## ON-SITE SEWAGE DISPOSAL SYSTEM HOWARD COUNTY HEALTH DEPARTMENT BUREAU OF ENVIRONMENTAL HEALTH

03-334465

SUBDIVISION: The Estates at Sandhill LOT NUMBER: 12

ADDRESS: 2101 Grant Farm Court PROPERTY OWNER: Oak Hill Properties

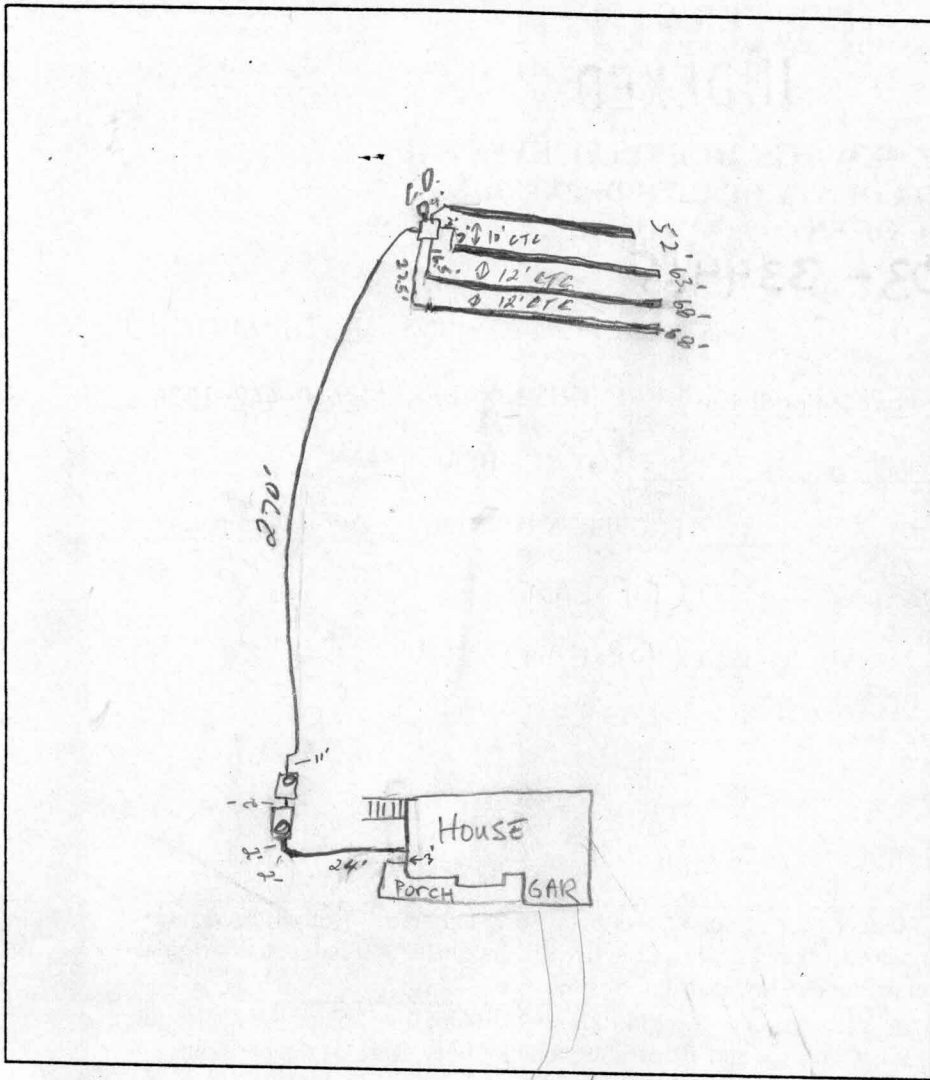
PRE-CONSTRUCTION INSPECTION: 10/24/01 HOUSE ELEV. REQUIRES BASEMENT PUMP.

S.T. LOCATIONS ADJUSTED TO L. SIDE OF HOUSE; OK TO START PER PLAN MR.

INSPECTION COMMENTS: 10/25/01 OK CONTINUE (KG)

10/26/01 Tanks set, no house connection, 2" sch 40 to DB. Told to put

baffle on inlet of P.T. OK to cover (S) 10/11/01 House conn. made,

trenches complete, OK to cover all work, alarm & pump test needed (S)

1/22/02 Pump NOT OPERATIONAL - Olen will call in reinspection (KG) 1/23/02 Pump

& Alarm OK (S)
